METROPOLITAN GOVERNMENT OF NASHVILLE AND DAVIDSON COUNTY

STAFF RECOMMENDATION 2116 Grantland Avenue August 20, 2014

Application: Partial demolition; New construction--addition
District: Woodland in Waverly Historic Preservation Zoning Overlay
Council District: 17
Map and Parcel Number: 10510032100
Applicant: Michael Ward, Allard Ward Architects
Project Lead: Melissa Baldock, melissa.baldock@nashville.gov

Description of Project: Application is to demolish a non-historic portion of the house and to construct a side addition. The addition will extend approximately six feet (6') beyond the existing right side wall of the historic house.

Figures 2 & 3 show the rear portion of the house to be removed and reconstructed.

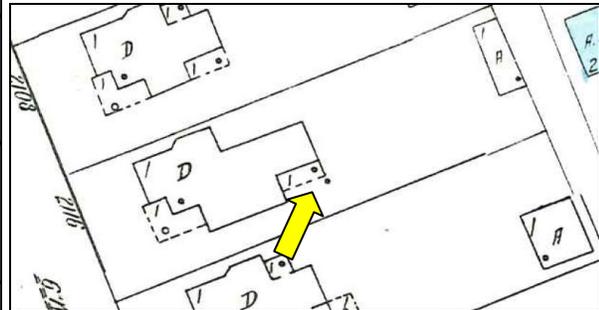
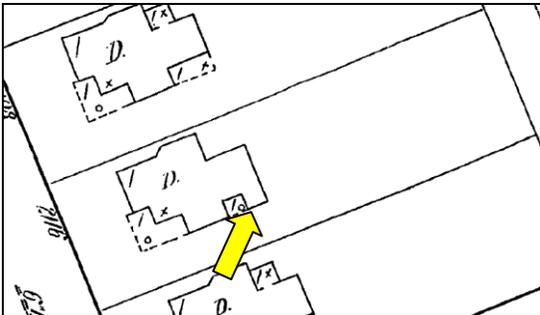
Partial Demolition: The applicant is proposing to remove and reconstruct a non-historic portion of the rear of the structure (Figures 2 & 3). An analysis of historic Sanborn maps shows that the portions of the house that are to be removed and reconstructed were not in their current configuration as late as 1957 (Figures 4 & 5). Staff therefore finds that the existing conditions of the rear portions of the right side elevation do not contribute to the historic character of the house, and their removal and reconstruction meet the design guidelines. The applicant is also proposing to remove two existing window openings at the rear of the structure, right façade, and install new window openings (Figure 6). Staff finds that these existing windows are not original to the house, as they do not have typical historic window proportions and the windows themselves are not historic. Staff therefore finds that the alteration of these window openings meets the design guidelines.

Staff finds that the removal and reconstruction of part of the right façade at the rear, and the alteration of the window openings on the right façade meet Section V.B.2. for appropriate demolition, and do not meet Section V.B.1. for inappropriate demolition.

Figure 6. The window openings that are to be altered.

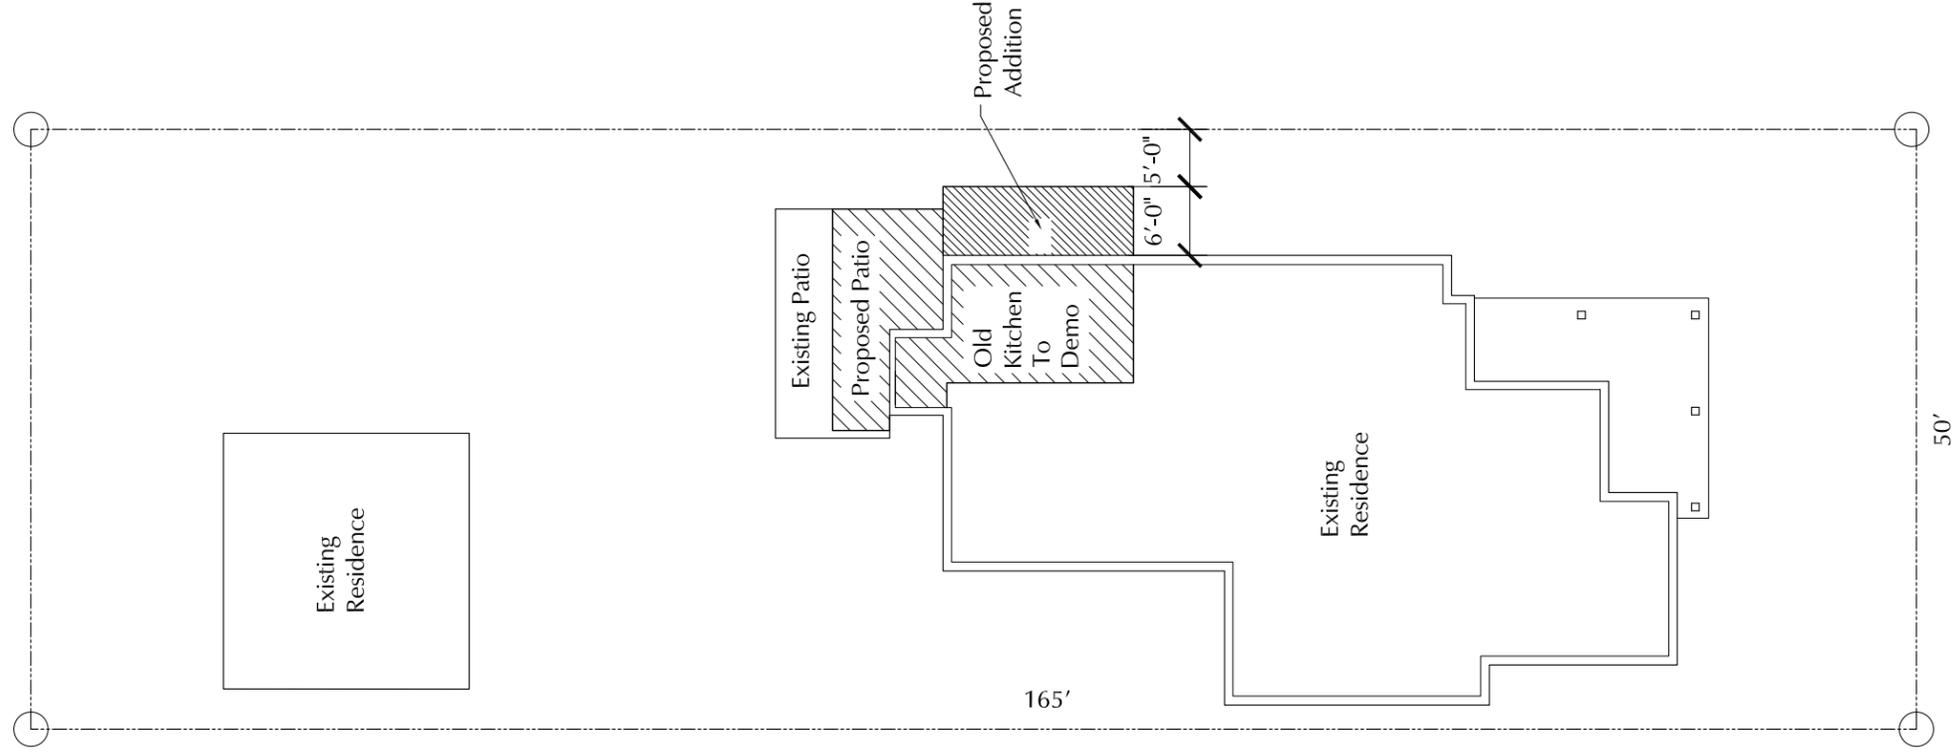
Proportion and Rhythm of Openings: The windows on the proposed addition are generally twice as tall as they are wide, thereby meeting the historic proportions of openings. There are no large expanses of wall space without a window or door opening. The applicant is proposing to alter two window openings on the existing house, on a non-historic portion of the right façade. The new window configuration will better match the historic proportion of window openings. Staff therefore finds the project's proportion and rhythm of openings to meet III.B.1. and III.B.2.g. of the *Woodland-in-Waverly Historic Preservation Overlay: Handbook and Design Guidelines*.

3 Side Elevation

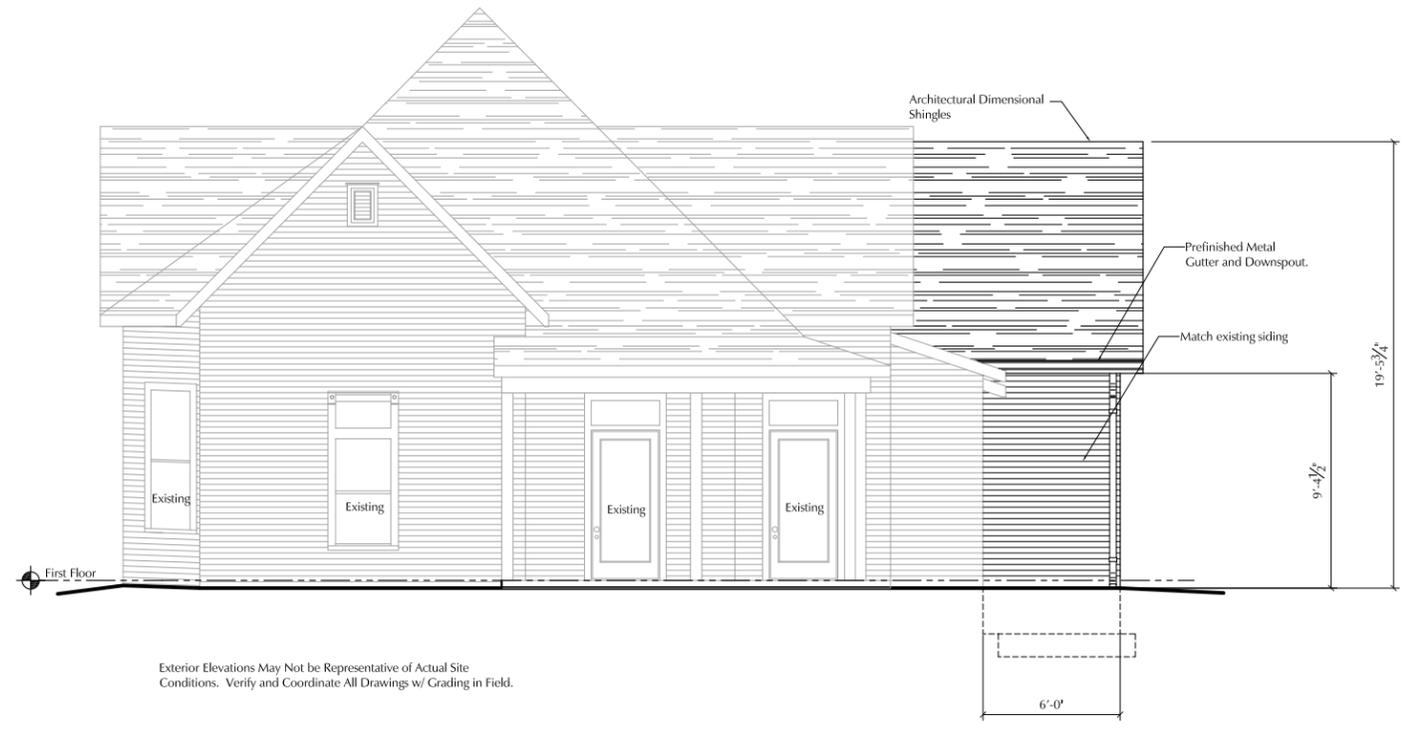
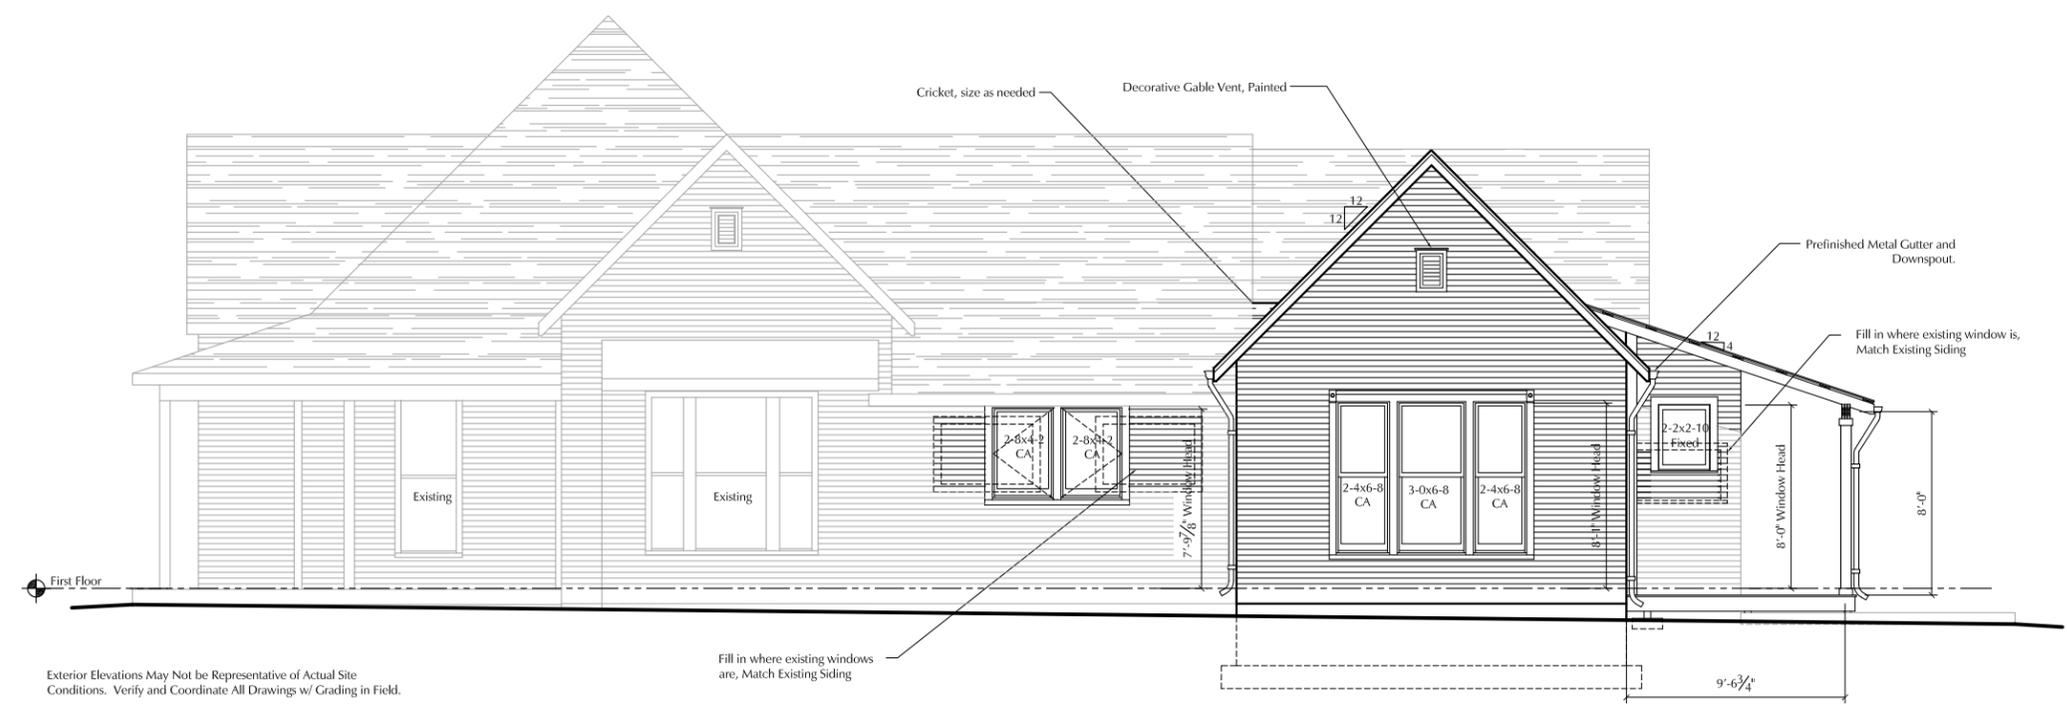
The addition's foundation height will match that of the existing house. Its eave height will be approximately ten feet (10'), which is slightly taller than the nine foot (9') eaves at the front of the house, but shorter than the twelve foot (12') tall eaves found on the historic portion of the right side elevation. The addition's ridge height will be approximately twenty feet, six inches (20'6"), which matches the ridge height of the rear

portion of the house and is lower than the house's maximum ridge height of approximately twenty-six feet (26'). Staff finds that the addition's height and scale are subordinate to the historic structure and meet sections III.B.1., III.B.2.a., and III.B.2.b. of the *Woodland-in-Waverly Historic Preservation Overlay: Handbook and Design Guidelines*.

Design: The addition is distinguished from the historic portion of the house with a side gabled roof form. At the same time, the addition's subordinate eave and ridge height, its modest footprint, and its location far back from the front wall of the house, ensures that it does not contrast greatly with the historic house. Staff therefore finds that the addition meets sections III.B.1.c. of the *Woodland-in-Waverly Historic Preservation Overlay: Handbook and Design Guidelines*.

Roof form: The primary roof form for the addition will be a side gable with a slope of 12/12 to match the historic house's roof pitch. At the rear, a 4/12 shed roof will cover the patio. Staff finds that the addition's roof forms meet sections III.B.1. and III.B.2.e. of the *Woodland-in-Waverly Historic Preservation Overlay: Handbook and Design Guidelines*.

Staff recommends approval of the project with the condition that staff approve the foundation material and the window and door specifications prior to purchase and installation of these materials. With this condition, staff finds that the project meets Sections III.B.1., III.B.2., and V.B.2. of the *Woodland-in-Waverly Historic Preservation Overlay: Handbook and Design Guidelines*.
